Appendix 4 – Picardy Place Proposed Layout (January 2018)

Appendix 5 – Summary of Consultation Feedback (in addition to paragraphs 3.26 – 3.38 in the report)

Appendix 6 – Picardy Place Public Realm Design Concept

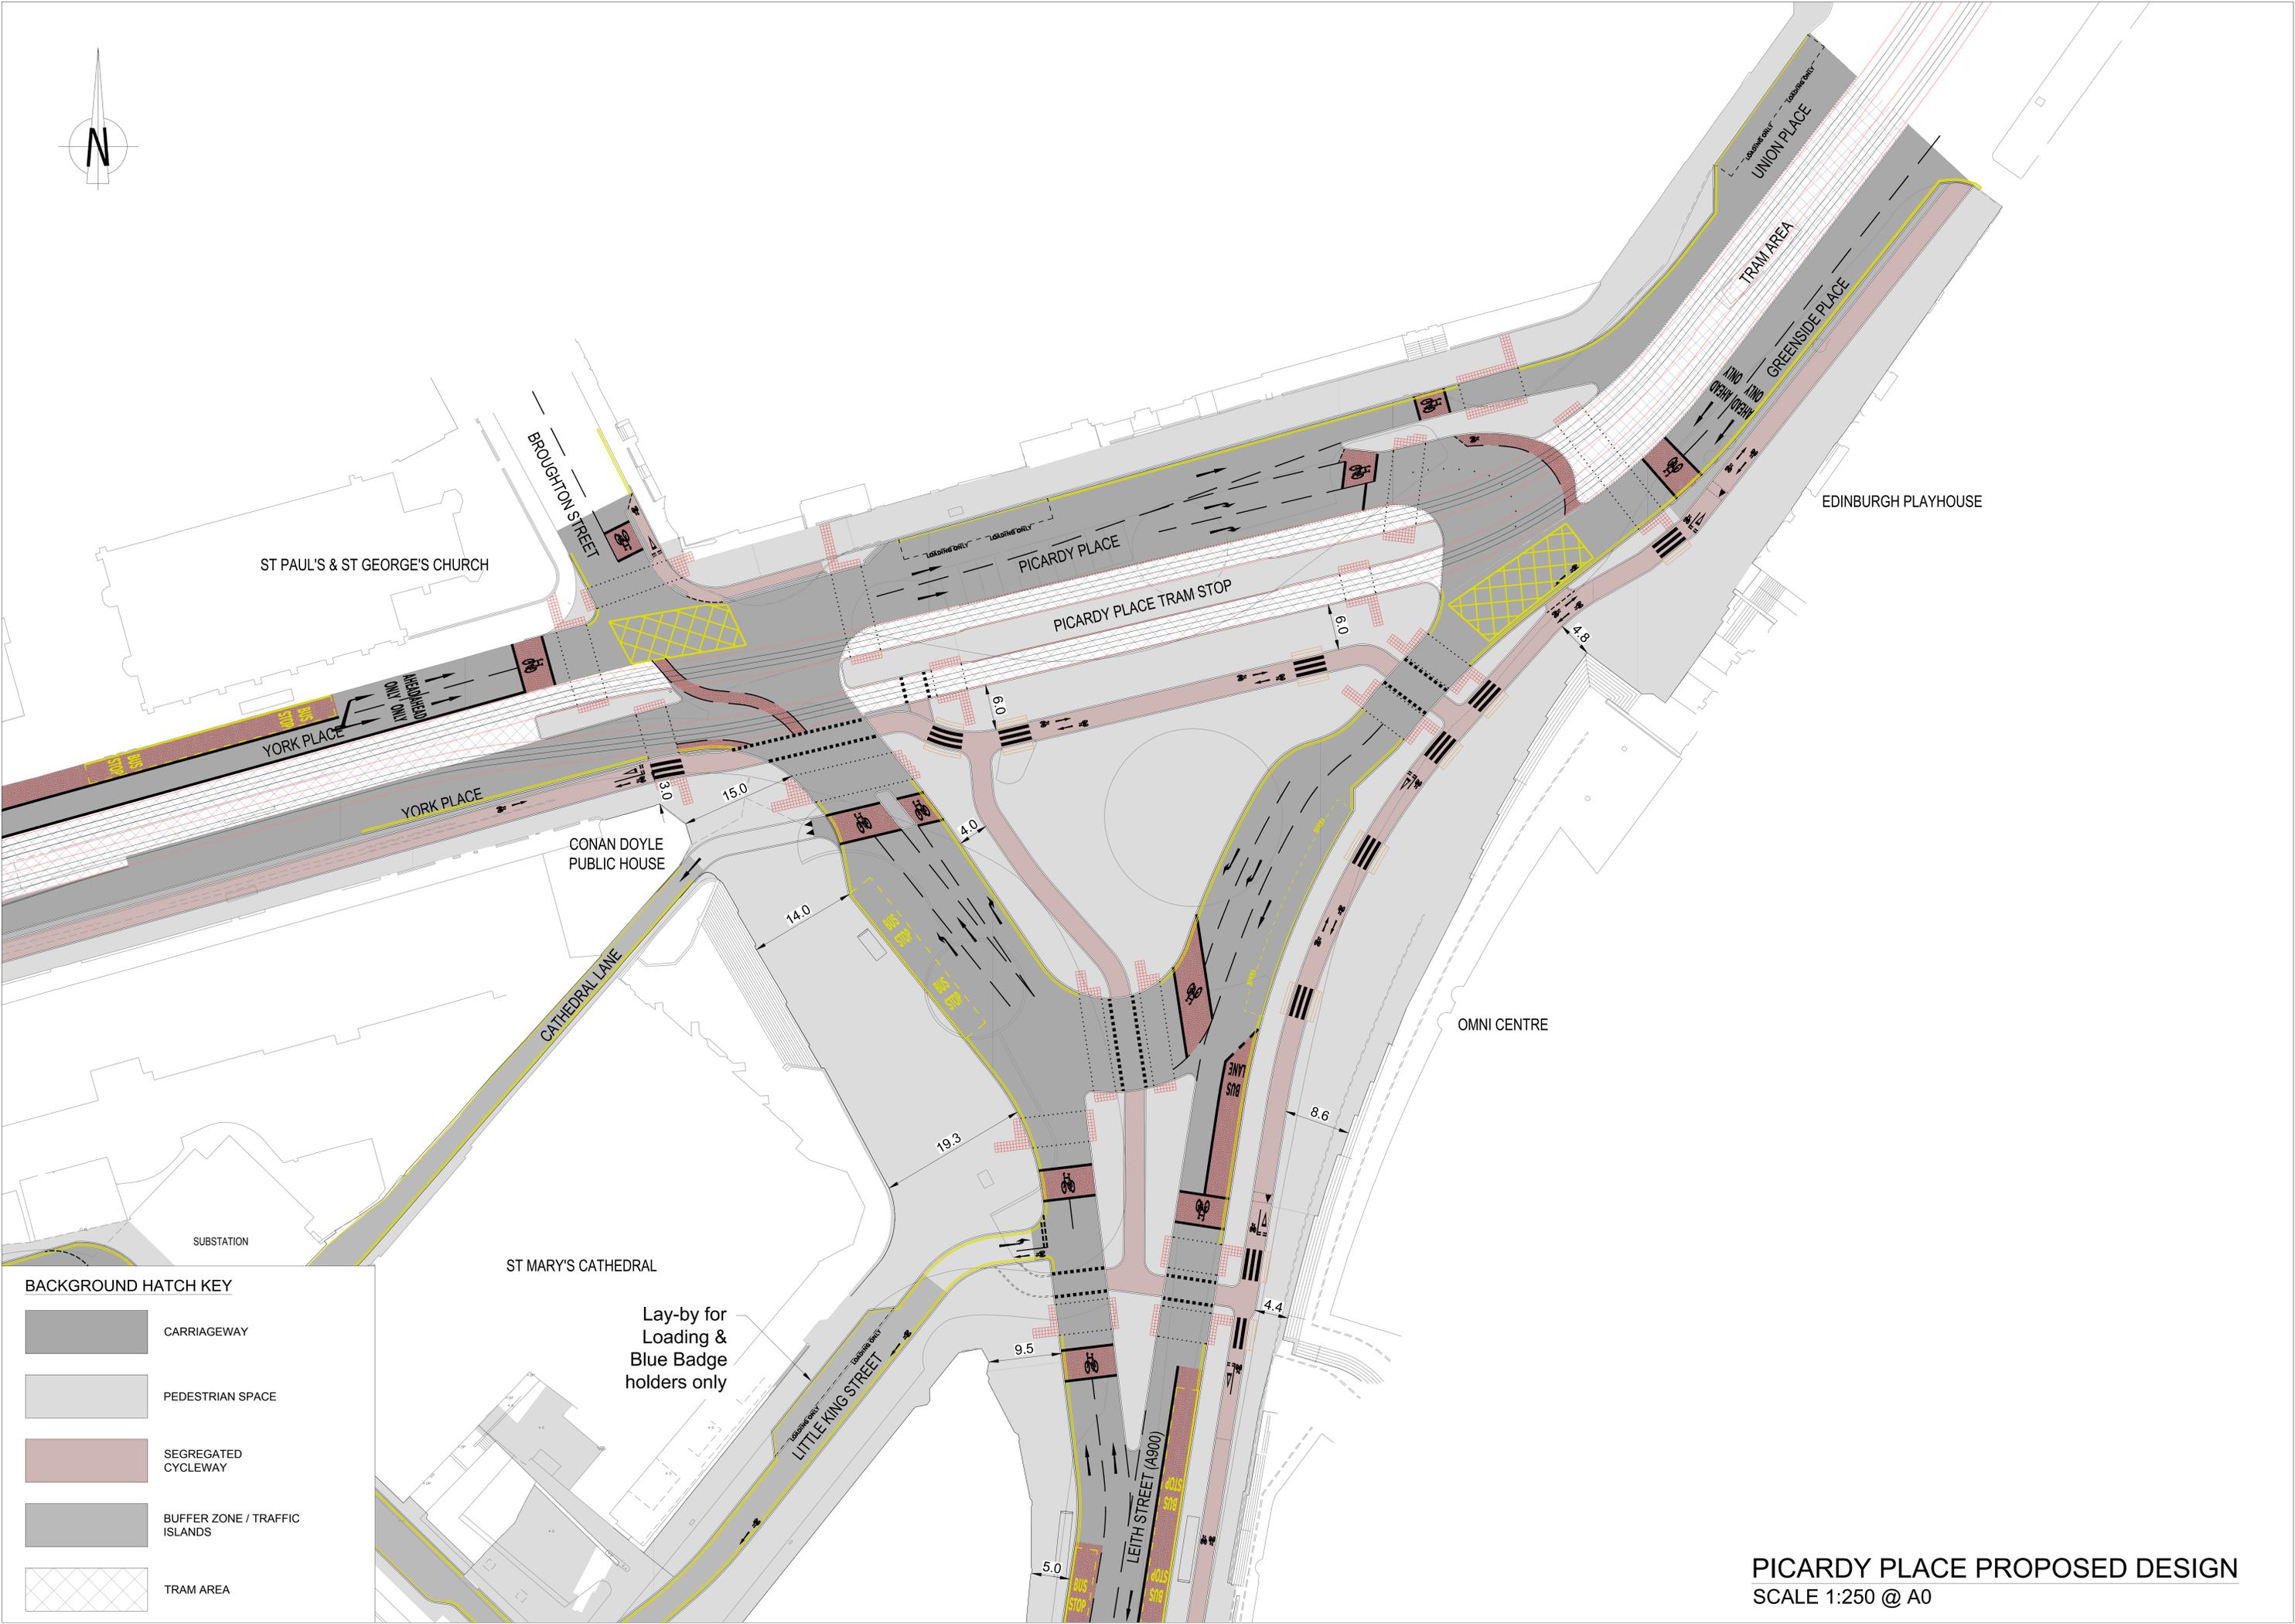
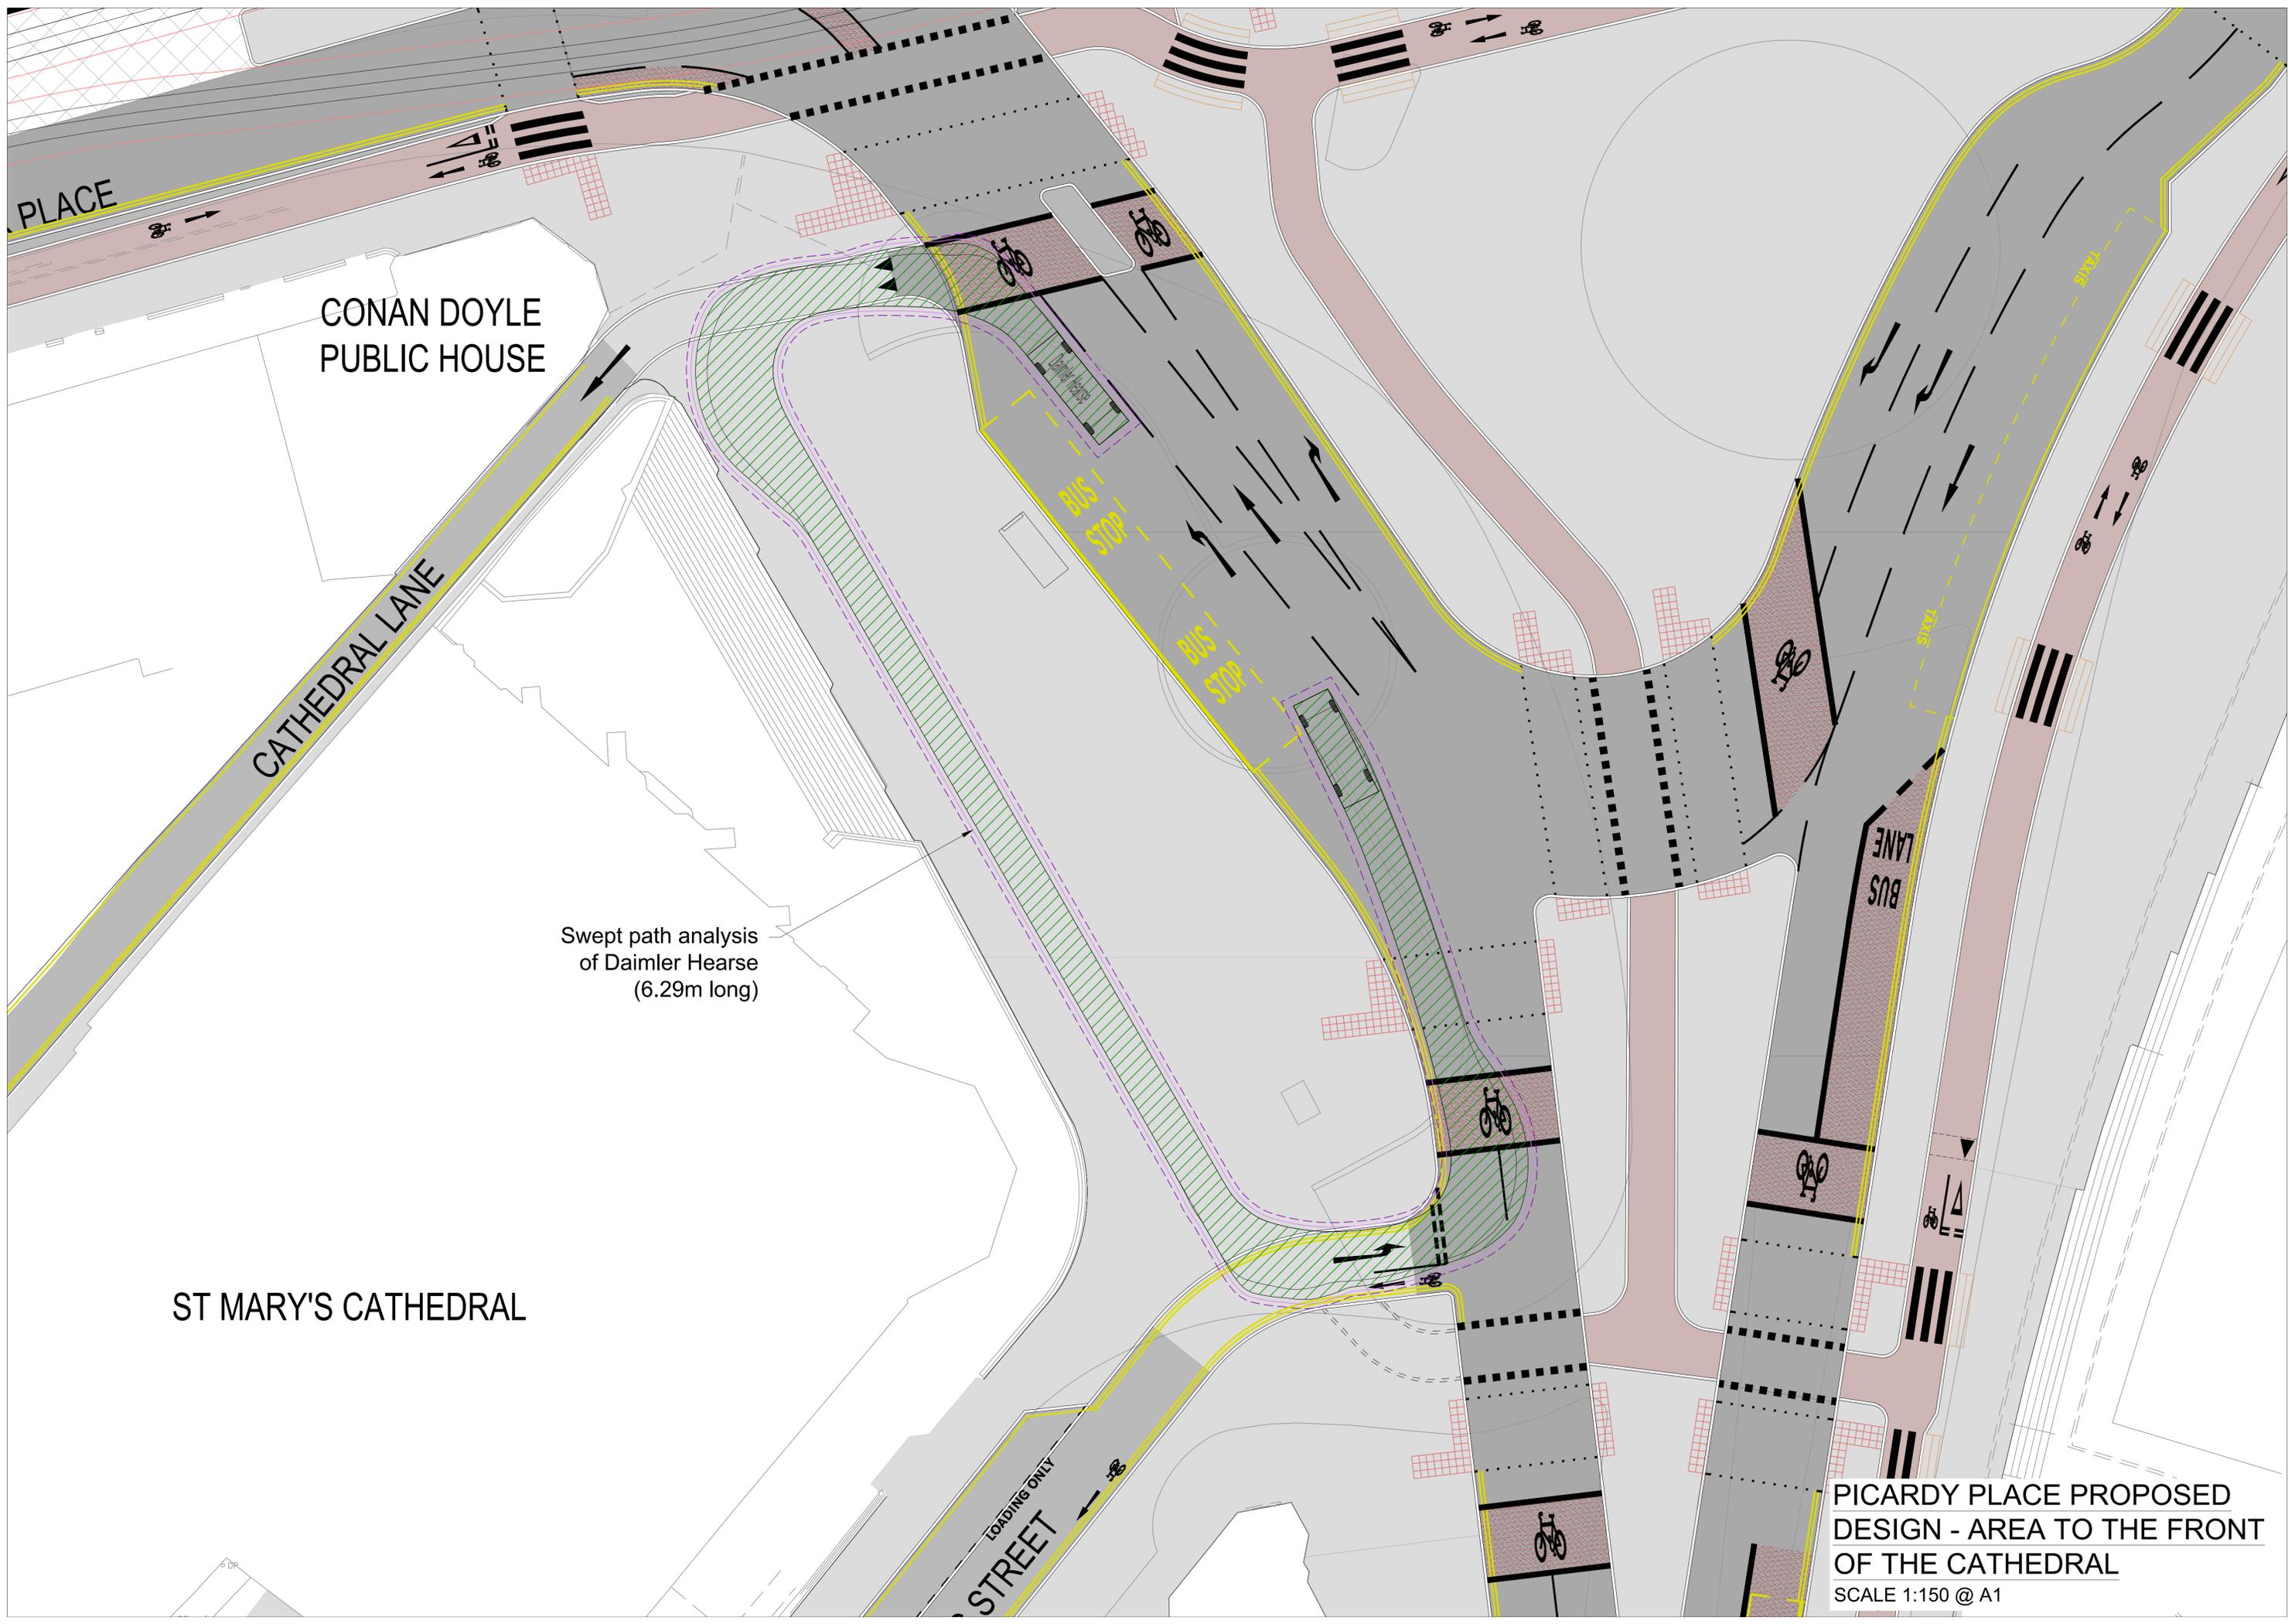
<p>The Paolozzi's should not be split across Little King Street, but should be preserved together and should remain</p>	<p>The previous drawings that were consulted on did show the Paolozzi sculptures being separated by the road. This was purely to give an indication of where they might go.</p>

<p>The crossing outside of the Playhouse is well-used should reflect pedestrian desire lines.</p>	<p>This came out strongly in the consultation and the design has taken this into account while also futureproofing for tram.</p>
<p>What are the plans for landscaping / greening of Picardy Place? The loss of trees in this location is a concern.</p>	<p>Landscaping and greening will form a key component of the public realm strategy for Picardy Place which is currently being developed.</p>
<p>Why does an island site need to be created?</p>	<p>The approved schedule of GAM works (appendix 2) was considered by Council in March 2016 and included the layout for Picardy Place. In order to future proof for an extension of the tram route, an 'island site' is created with a 70 metre requirement for a tram stop at this location. Finally, this layout is crucial in allowing the existing transport network to work effectively and this proposal assists in future proofing this location for transport interchange improvements in the future.</p> <p>There was significant feedback that the central island should not be developed at this time but retained for public realm. To accommodate the changes to public realm outside the Cathedral and the reinstatement of</p>

<p>It will be unappealing with traffic, air pollution and noise all around it and the wider area could attract anti-social behaviour.</p>	<p>The public realm design for the Picardy Place area will take account of this and will incorporate measures to minimise the impact of traffic, air pollution and noise.</p> <p>The public realm strategy will also seek to also address concerns raised about anti-social behaviour in this area.</p>
<p>The proposed taxi rank at Little King Street is not appropriate.</p>	<p>The proposed design incorporates a taxi rank outside the Omni Centre, rather than on Little King Street.</p>
<p>Access to the Cathedral entrance is required for funeral and marriage cortèges.</p>	<p>The proposed design incorporates the need for access to the Cathedral for this purpose.</p>
<p>The parking bay on Little King Street should have yellow lines to allow disabled parking and enlarged.</p>	<p>The proposed design extends the parking bay on Little King Street and includes double yellow lines.</p>

<p>outside of the cathedral or relocate to an attractive location on the island site.</p>	<p>In discussion with the Paolozzi Foundation, St Mary's Catholic Cathedral and Sir Tom Farmer, who gifted the sculptures to the city, a location (either outside the Cathedral or on the central island site) will be agreed in due course.</p>
<p>Can Leith Street be kept closed to private vehicles except for access? This would demonstrate a significant commitment to reducing traffic volumes and appears to be possible, since this is happening now.</p>	<p>Leith Street will re-open at the end of July 2018 following completion of the current works.</p> <p>Edinburgh only has three key North-South routes (Leith Street, Mound and Lothian Road).</p> <p>A Central Edinburgh Transformation project has been established and is being progressed in line with the report approved by Transport and Environment Committee on 5 October 2017 and this will include reviewing the three North-South routes in the city.</p> <p>Recommendations on this will be brought forward by the end of 2018.</p>

<p>space outside the Omni Centre, the proposed design (appendix 4) has significantly reduced the size of the central island site. The island site is also crucial to allowing our existing transport system to work effectively. The Council plans to use the island site as public realm for people to walk and cycle across.</p> <p>Detailed plans for this site will be published in due course.</p>
<p>The island site is Inaccessible / inconvenient and people won't want to cross to go through it or it will be too difficult to cross into.</p>	<p>There are multiple crossing points for pedestrians and cyclists to access the island site. It should be remembered that a single tram can carry 240 passengers so there will be a lot of pedestrian activity in this area, should the tram go ahead.</p> <p>The addition of two cycle lanes at this location also provide direct links to the CCWEL and between Broughton Street and Leith Street.</p>
